TSB140168
-----------

## Technical Service Bulletin

New Cummins® Service Tool Fuel Return Hose and Updated Procedure for ISX and QSX Engines with Common Rail Fuel Systems

This document announces a new Cummins® service tool fuel return hose and updated service manual procedure.

## Fuel Pressure Relief Valve Return Flow Test

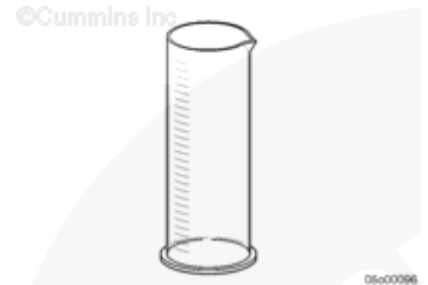
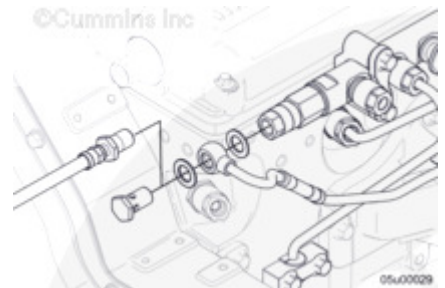
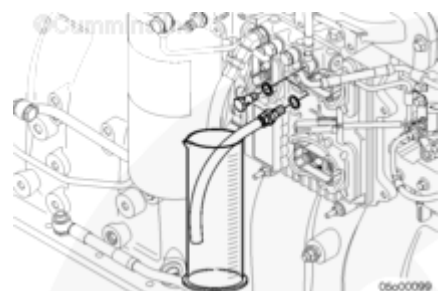
The fuel pressure relief valve return flow test has been revised to state that the fuel pressure relief valve return flow should be measured at the fuel rail and **not** at the fuel drain manifold.

Measurement of the fuel pressure relief valve return flow at the fuel drain manifold is acceptable if there are accessibility issues. If the fuel pressure relief valve return flow is measured at the fuel drain manifold and the fuel flow is found out of specification, the fuel pressure relief valve return flow measurement **must** be repeated at the fuel rail.

pump head through three different drain lines. Measurement of fuel injector leakage requires the use of a fuel return hose, Part Number 5299319.

Remove the banjo bolt from the drain line at the fuel pressure relief valve.

Install banjo flow adapter fitting, Part Number 5299319, at the fuel pressure relief valve.

- Alternatively, fuel return hose Part Number 3164618, can be installed at the fuel drain manifold.
- If the fuel rail return flow does **not** meet the specification when checking at the fuel drain manifold, then measure the fuel rail return flow at the fuel rail pressure relief valve, **not** at the fuel drain manifold.
- If the fuel rail return flow does **not** meet specification at the fuel rail pressure

relief valve, then a malfunctioning fuel rail relief valve has been detected.
